Biomass Boilers at Waste Drying Plant, Gibson Lane, Melton, Hull, HU14 3HH

Odour Management Plan Update - Schedule 5 Request

16th September 2022

Figure 4-3. Odour Sniffing Test Locations

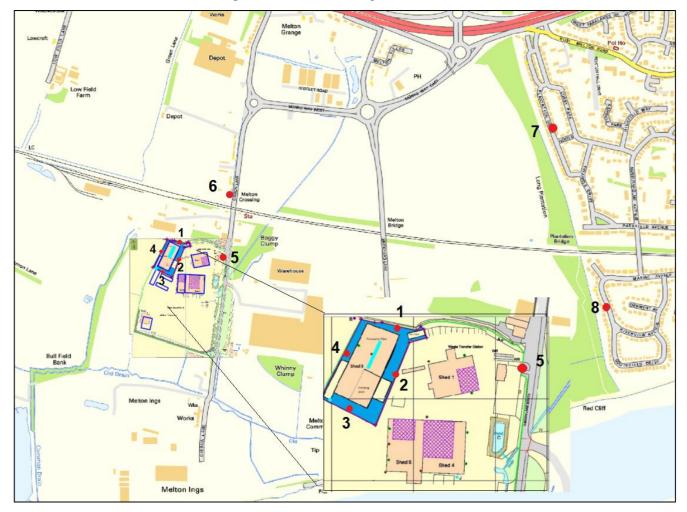
- 20. Consider alternate odour monitoring location points, especially in the North Ferriby area.
- 21. Confirm the location and purposes of the monitoring locations on figure 2 of the OMP that appear to be within or on top of the building.

Two of the primary potential sources of odour will be the emission stacks from the boilers and drying plant. The proposed odour monitoring locations (Figure 2 OMP) are unlikely to monitor any odour from these as the emissions may not have fully mixed or reached ground level.

The plan of proposed monitoring locations includes 2 locations that appear to be either within the building or on top of the building.

The sniffing testing will be undertaken at 8 locations shown **Figure 3-1**.

Figure 4-3The sniffing test should be undertaken at the 4 site boundary locations No. 1 to No. 4. If it is expected the odour has migrated outside of the boundary. Further sniffing testing will be undertaken. For example, if wind direction is westerly and south-westerly, sniffing test will be undertaken at Location 5 and Location 6. Furthermore, if the odour detected at those two locations (Locations 5 and 6) are most likely from the Eco-Power operations

(other than the neighbouring waste operations), sniffing test will be undertaken at Location 5 and Location 6, sniffing test needs to be undertaken at Location 7 and Location 8 at North Ferriby Area.

Figure 1-5. Fire Prevention and Mitigation Plan

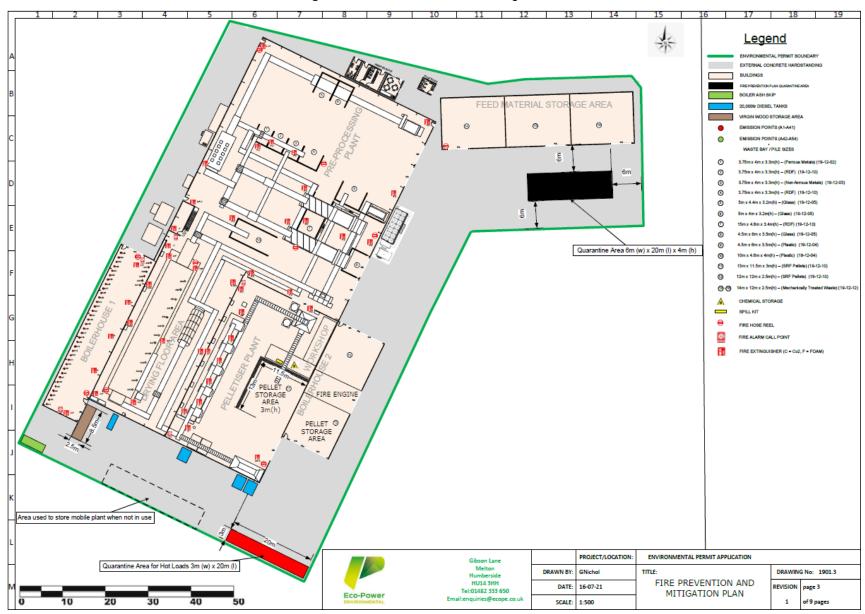
Provide an up-to-date plan of the site to replace the site layout plan (and other appropriate site plans referenced in management plans).

The updated site plan is shown in *Figure 1-5* below.
